**ZONING AND PLATTING  
SITE PLAN VARIANCE REQUEST BONUS REVIEW SHEET**

**CASE NUMBER:** SP-2020-0400D

**PROJECT NAME:** HEB Austin No 33

## ENVIRONMENTAL COMMISSION MOTION 20210119-004b

OVERALL SITE PLAN

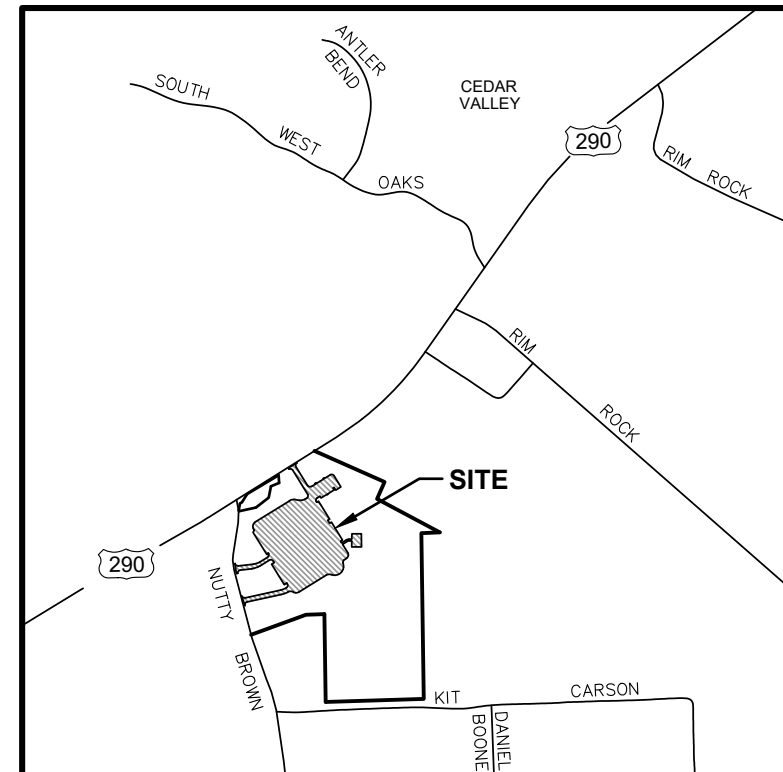
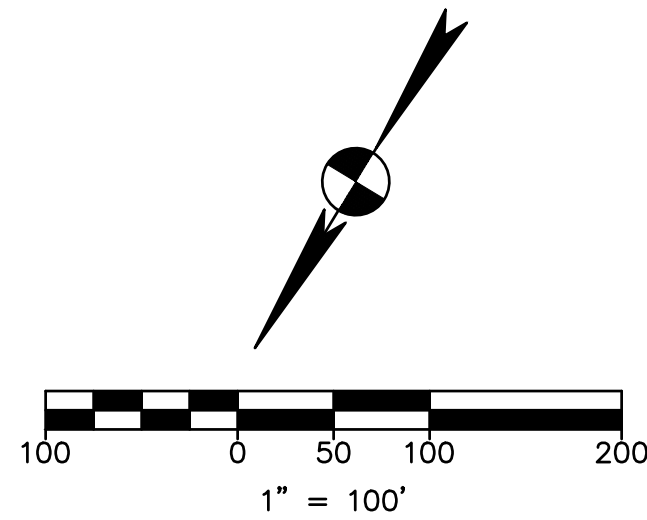
1. Request to vary from LDC 25-8-341 to allow cut to 12 feet.
2. Request to vary from LDC 25-8-342 to allow fill to 21 feet.
3. Request to vary from LDC 25-8-302(A)(2) to allow construction of a parking area on a slope with a gradient of more than 15 percent.
4. Request to vary from LDC 25-8-301 to allow construction of a driveway on a slope with a gradient of more than 15 percent.

The request is for four variances: from LDC 25-8-341 to allow cut to 12 feet, from LDC 25-8-342 to allow fill to 21 feet, from LDC 25-8-302(A)(2) to allow construction of a parking area on a slope with a gradient of more than 15 percent, and from LDC 25-8-301 to allow construction of a driveway on a slope with a gradient of more than 15 percent. The variances are allowed by LDC 25-8-41, if the findings of fact set forth in that provision are met. Due to the slopes on the site, the overall fall in elevation, and constraints imposed by the environmental sensitivity of the area, this project has been judged to meet the findings.

1. The variance request is to allow **cut** over 4 feet to 12 feet.
2. The variance request is to allow **fill** over 4 feet to 21 feet.
3. The variance request is to allow **construction of a parking area** on a slope with a gradient of more than 15 percent.
4. The variance request is to allow **construction of a driveway** on a slope with a gradient of more than 15 percent.

**VARIANCE:** Staff recommends these variances, having determined the findings of fact to have been met.

**Therefore**, the Environmental Commission recommends approval of the request with the following Staff Conditions:

1. Applicant will restore illegal fill that currently exists on the site to the original grade.
2. Applicant will use native plants appropriate for the Hill Country location for revegetation.
3. The applicant will provide mitigation in the form of payment or on-site plantings for removed trees with a diameter of 19 inches or greater at a rate of 100%.
